CERTIFICATE OF APPROPRIATENESS

Property: 1409 Ashland Street, Lot 16, Tract 17A, Block 151, Houston Heights Subdivision. The property includes a historic 1,114 square foot, one-story wood frame single-family residence and a detached secondary structure situated on a 6,600 square foot (50' x 132') interior lot.

Proposal: Alteration – Addition *Resubmittal*

EAST ELEVATION – FRONT FACING ASHLAND STREET

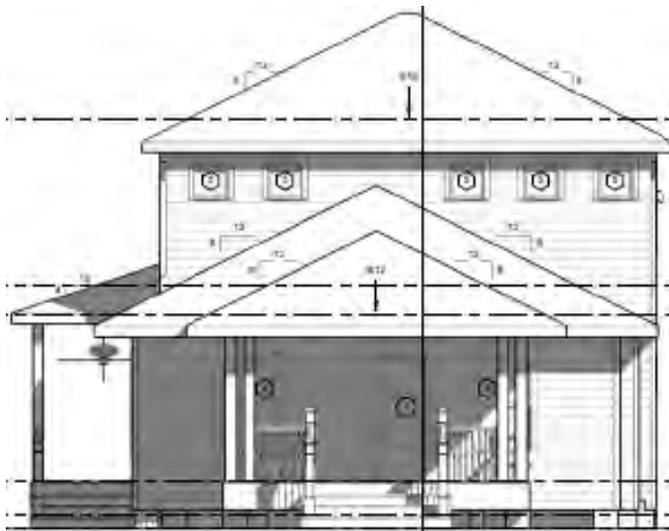
Front Elevation (East) On the front elevation, the applicant proposes to add two casement windows on the addition to go along with the approved three.

1409 Ashland – NO OBJECTION – Recommend original approved 3 windows on 2nd floor addition on the East elevation be maintained.

NORTH SIDE ELEVATION

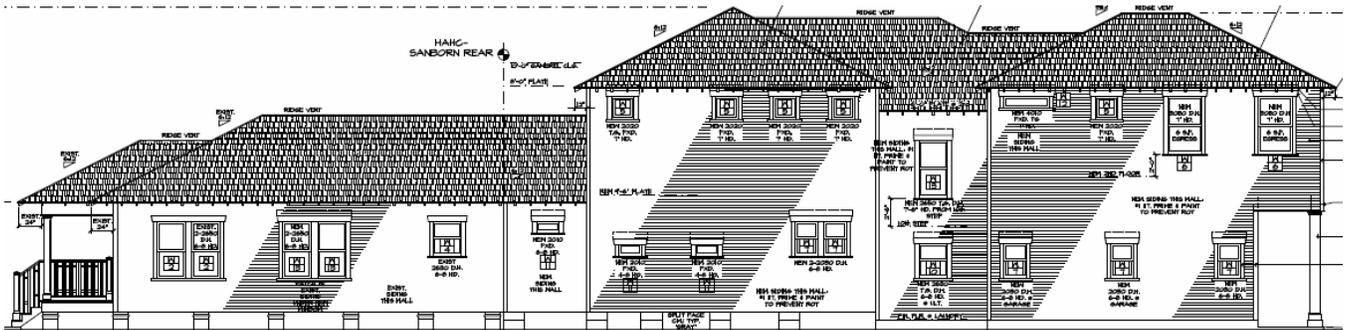
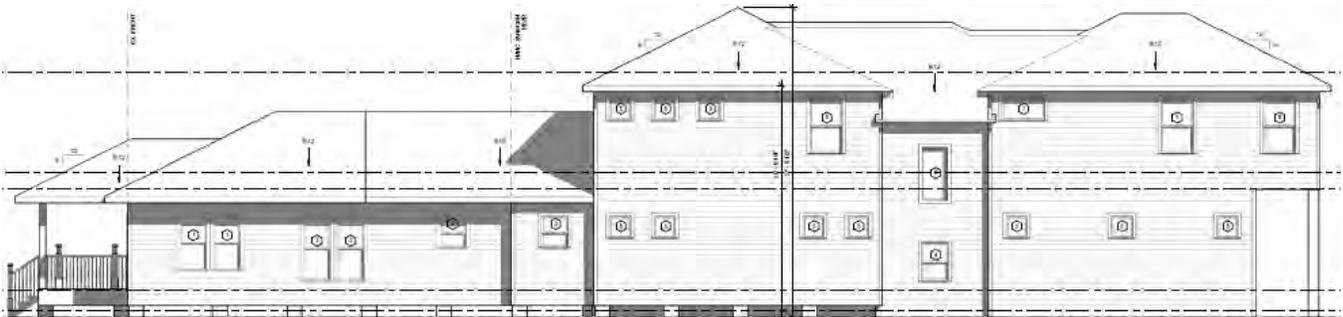
Proposed: (Viewing the drawings left to right) on the first floor of north elevation, the applicant proposes to shift a pair of casement windows towards the front of the structure, replace a pair of adjoining double hung windows with a pair of separated casement windows, and replace three double hung windows with casement windows at the attached rear garage. On the second floor, the applicant proposes to shift three approved casement windows towards the front of the structure, replace an approved double hung window with a casement window and omit an approved casement window on the second story of the attached garage.

SOUTH SIDE ELEVATION

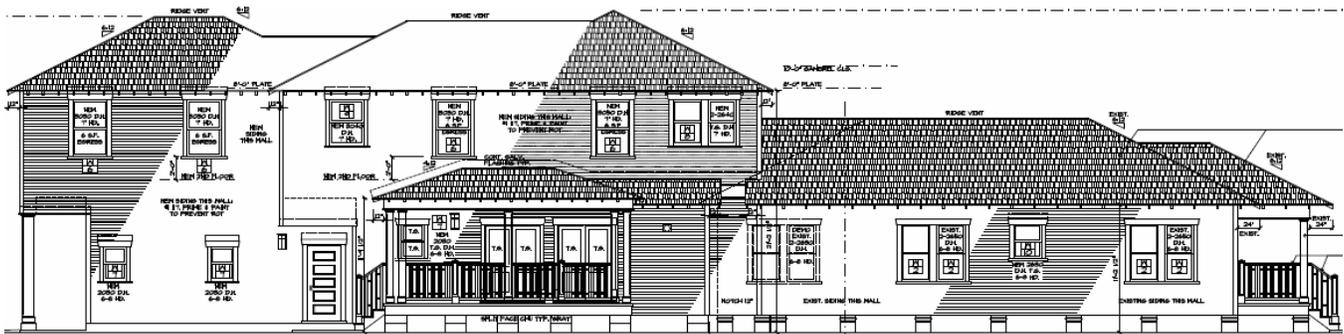
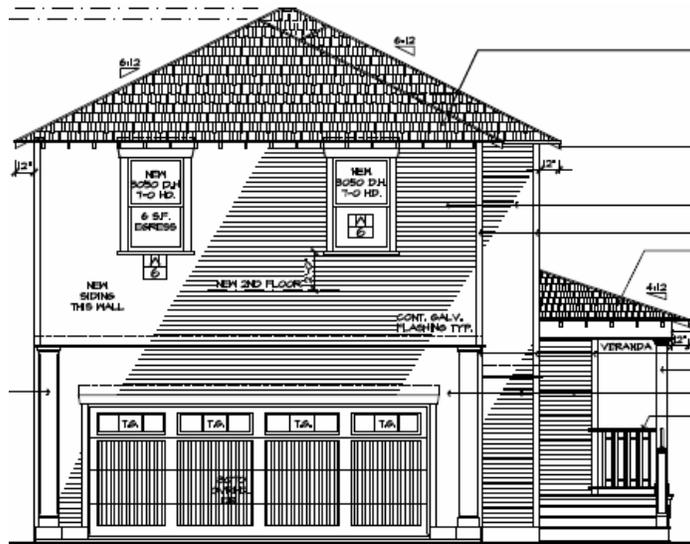
Proposed: An approved south facing chimney bump out on the rear addition will be removed. The approved south facing side porch will be extended over this area.

Proposed: On the first floor of the south elevation, the applicant proposes to add a third sliding door to face the side porch that is proposed to be expanded, and replacing a pair of double hung windows on the attached garage with casement windows. On the second floor, the applicant proposes to replace a pair of adjoining double hung windows and two separate double hung windows, with two pairs of adjoining double hung windows. An approved double hung window will be replaced with a casement window.
